I have reviewed your points below and there remains some confusion over the proposals for the refuse vehicle. I have provided some comments below in red.

Subject: RE: Bartons Road Travel Plan

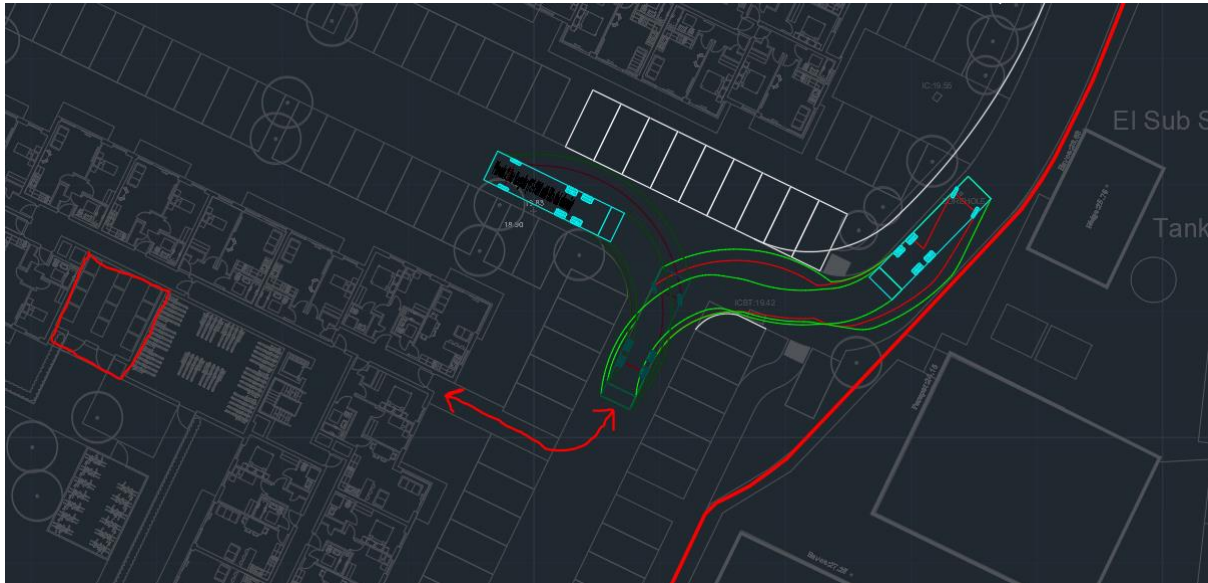
5. There are no turning heads within the development, so vehicles are turning around using parking spaces.

This relates to the end spaces shown near the Petersfield Road boundary and to the south of the site near Martin's Road where vehicles aren't able to reverse into the end few space and there is no turning area if someone goes down there and cant park. In addition full turning movements need to be undertaken in the aisle width, which are onerous. As this is going to remain private it is a comment that we have on the internal layout and a matter for your own consideration. It is also clear that not all

parking spaces are able to be used in a forward and reverse gear and therefore some spaces could be considered to be inaccessible. This point will be made to the PA within our response and it will be for them to determine if this needs to be addressed.

It is not a normal requirement to provide turning heads for cars as the 6.0m aisle width allows space for a five-point turn if required, as shown in the screenshot below. In reality it is likely that an empty car parking space would be available for use as an informal turning head if needed, meaning this movement wouldn't be required. The proposal is also that spaces will be unallocated therefore it is likely that empty spaces would be dispersed across the layout and we wouldn't anticipate residents having difficulty finding an empty space. This is supported by the fact that the proposed parking provision significantly outstrips the demand suggested by the 2011 census, as set out in the TA.

It would be possible to provide turning heads for cars however this would have implications for car parking provision and/ or landscaping which we don't think would be justified.

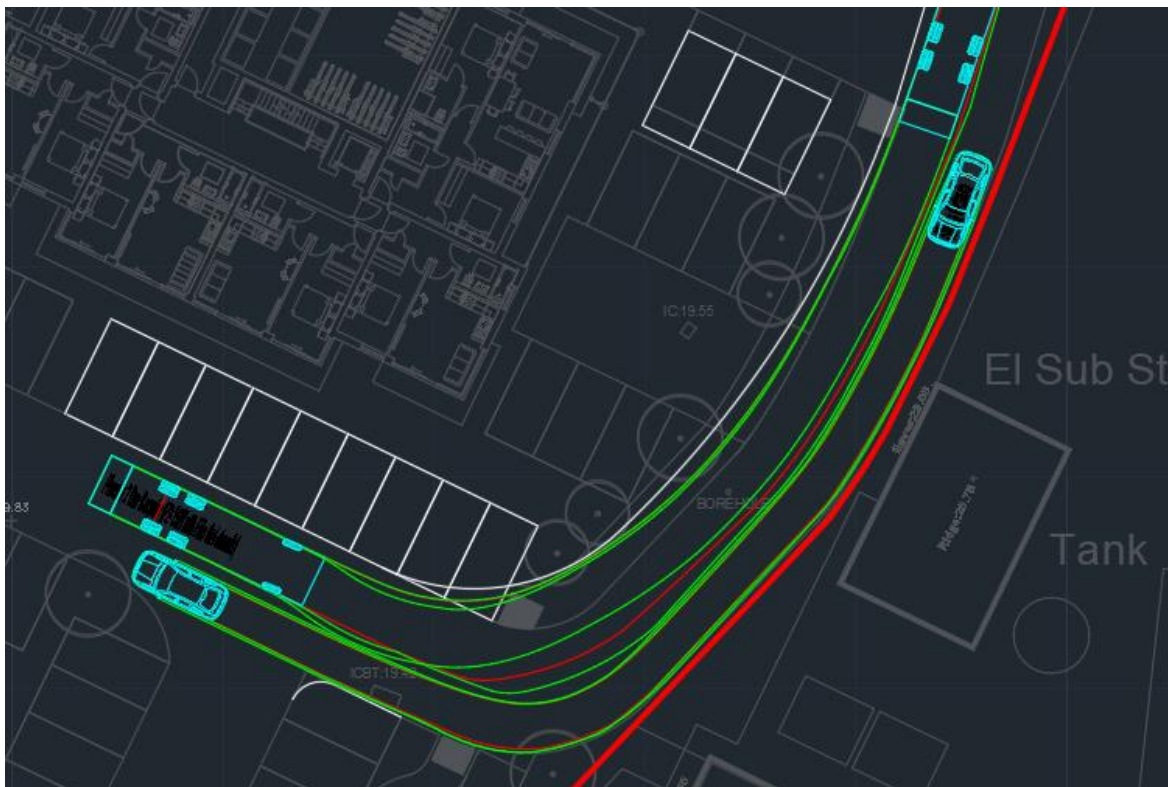
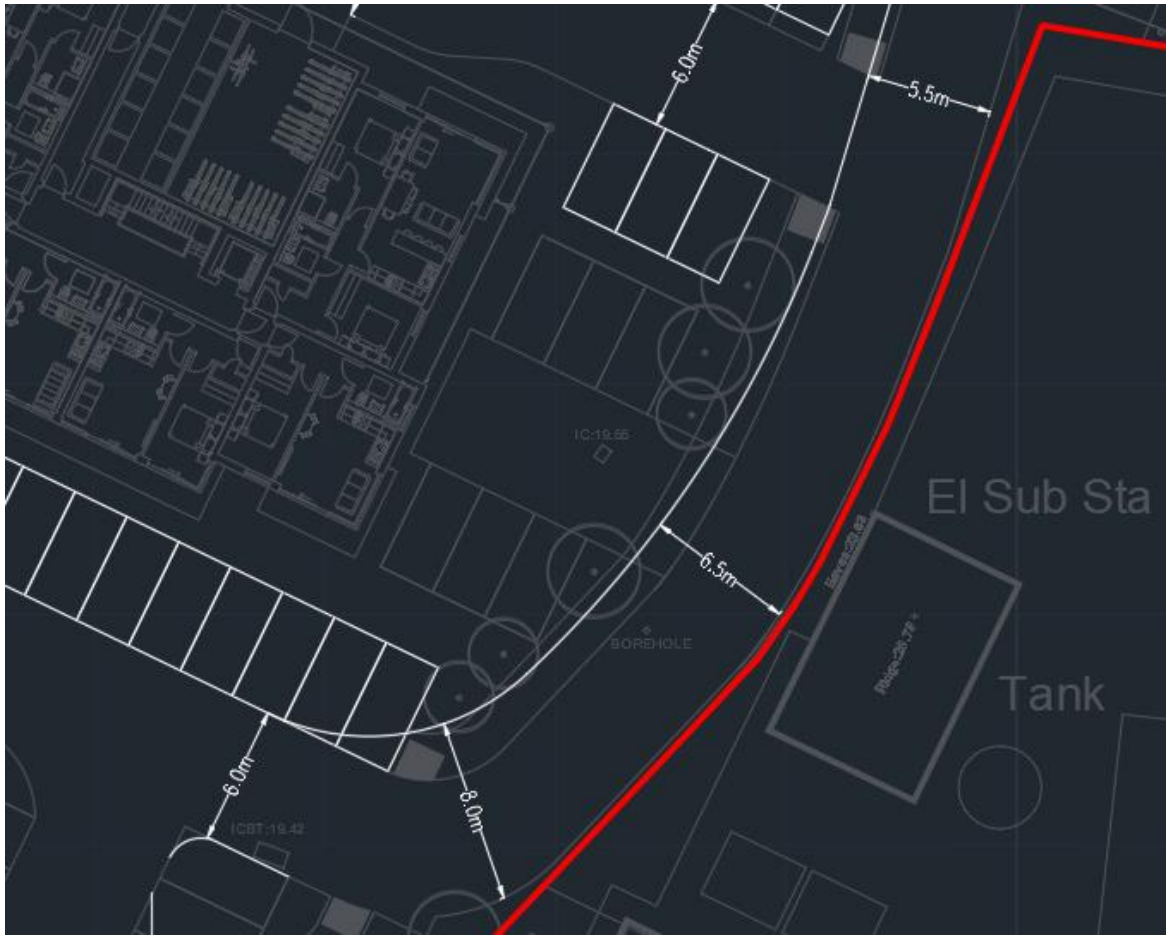
8. The internal road should be wide enough to allow the super-large refuse vehicle to pass a car, this will likely necessitate local widening on radii.

This is where I become unclear on what is proposed as the refuse vehicle is shown tracking a manoeuvre that it wouldn't undertake according to the suggestion above. Can you please be clear on what you are proposing. I can agree to the refuse vehicle not needing to be able to pass a car as long as appropriate visibility can be achieved.

The refuse vehicle will visit the site once per week and the chance of a refuse vehicle meeting an oncoming car at the apex of the bend in the access road is therefore minimal. In this worst case scenario, a car would be required to reverse slightly, in a low traffic and low speed environment. Indeed, cars will be required to reverse into and out of spaces daily. We therefore suggest that there should be no safety concerns with this scenario.

The bend could be widened to accommodate these opposing movements however this would have a significantly detrimental impact to the layout, in terms of parking, landscaping, and general appearance. It may also encourage higher speeds. The layout changes which would be required are shown approximately by the screenshot below which shows the bend widened to 8.0m. We suggest that this change would be an entirely disproportionate response to the perceived issue.

We are prepared to widen the bend as shown below, if considered absolutely necessary by HCC. However, we would recommend keeping the existing width which we consider represents a better design. We'd appreciate your views on this.

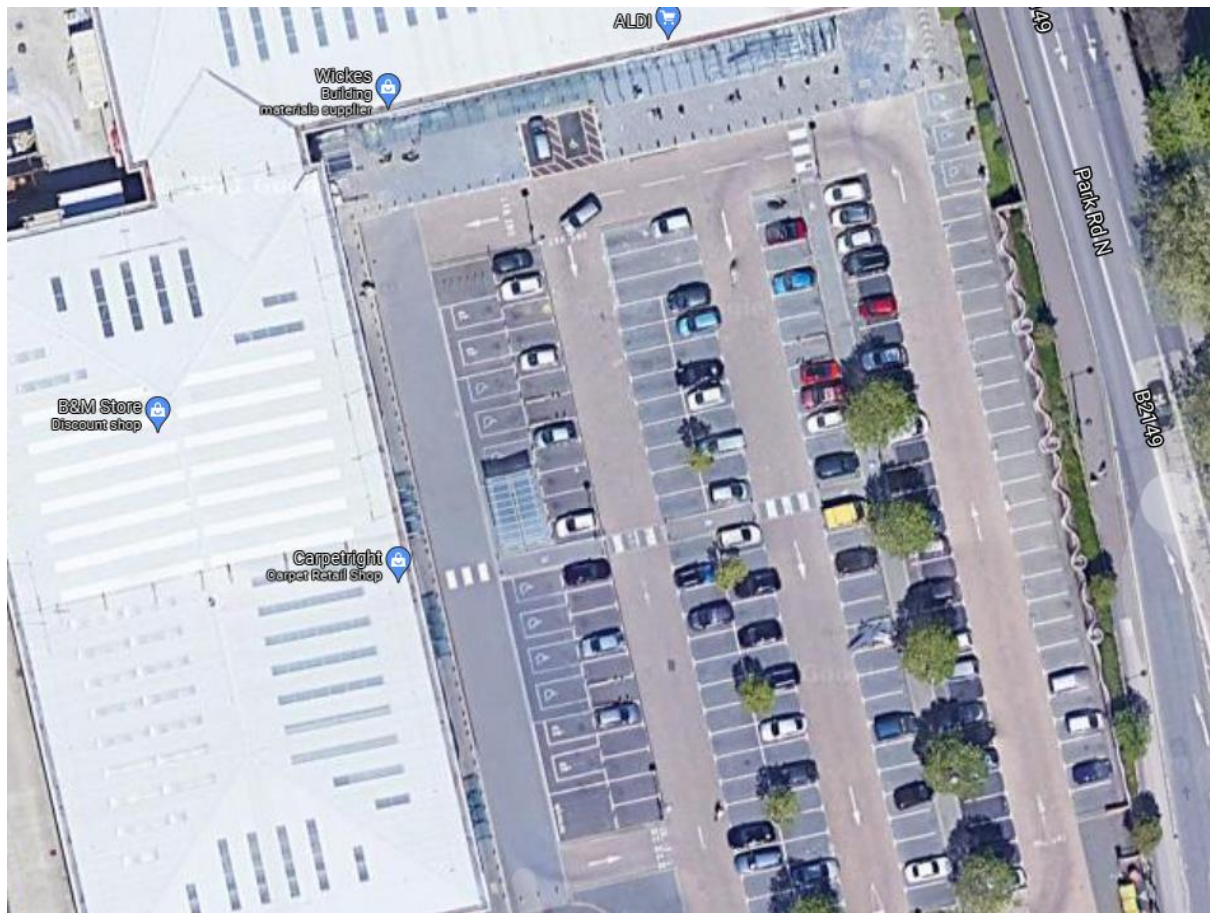
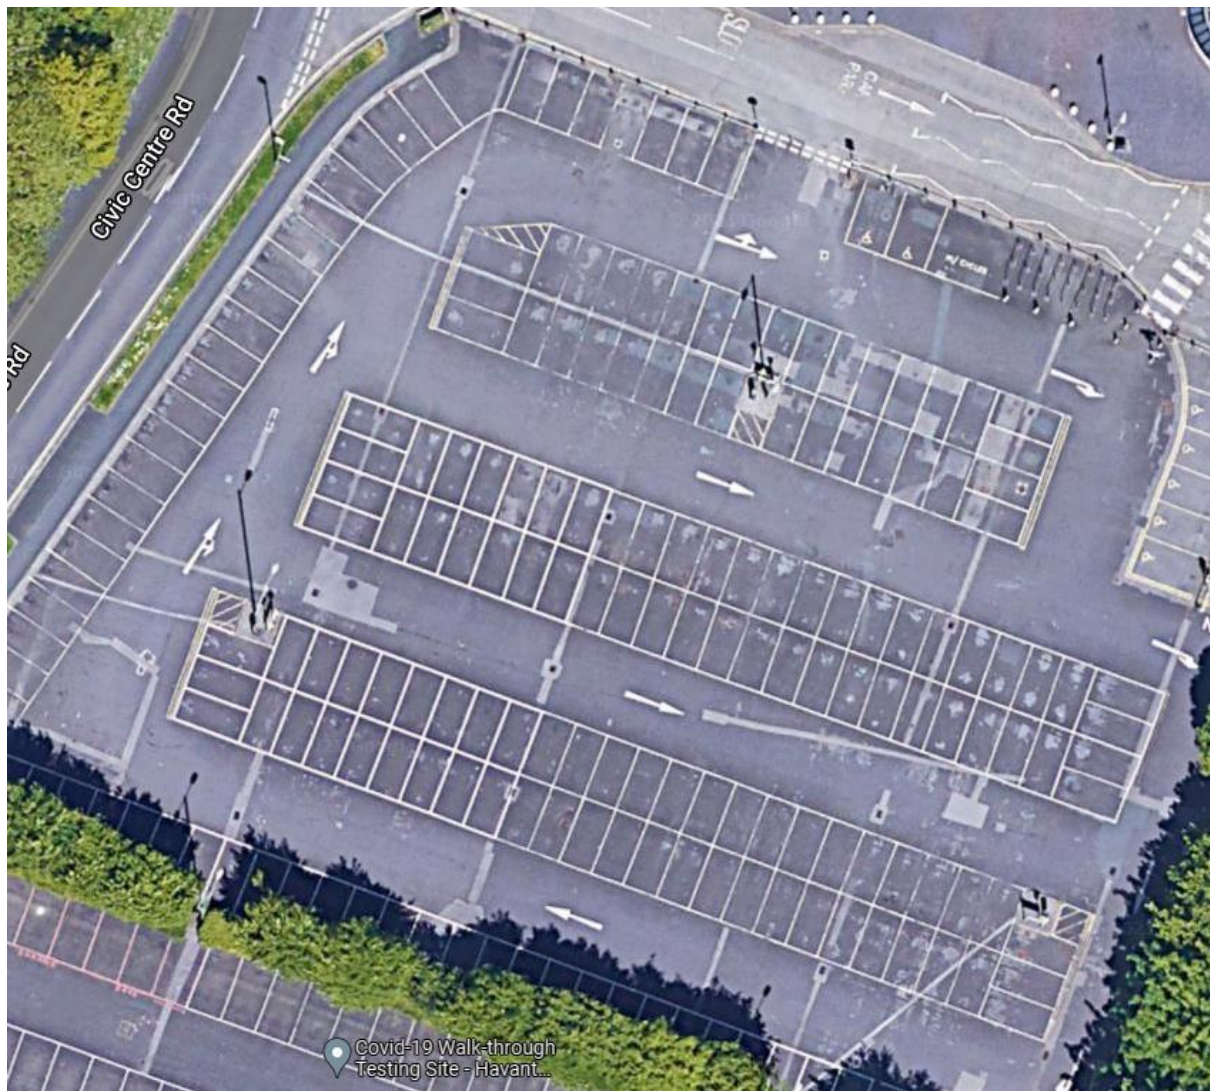
12. Visibility splays within the development have not been shown for comment and there appears to be crossing locations which would be obscured by parking.

The point regarding visibility splays is an important one to make and is one we shall make to the Planning Authority to consider more widely. My priority concern is in relation to the north south pedestrian route through the site which is potentially attractive to users as a through route. Rights should be granted for the public to pass and repass within the s106/conditions and appropriate visibility achieved for all crossings along this route. At present I don't believe this can be achieved at the 'S' bend but could be resolved in conjunction with the refuse vehicle tracking matters.

Pedestrian visibility unobscured by parked cars is not a normal requirement for car parks. Indeed, many car parks do not even provide formal pedestrian crossing points with pedestrians expected to use the aisles or move between cars. Many examples of these arrangements can be found in close proximity to the site as shown by the below screenshots.

Providing unobscured visibility splays at all pedestrian crossing points on the layout would have a significant impact and may either require a significant loss of spaces, or aisle widths being widened by 1.0-1.5m, which in turn may encourage higher speeds and be visually unattractive. We'd appreciate your view on this.
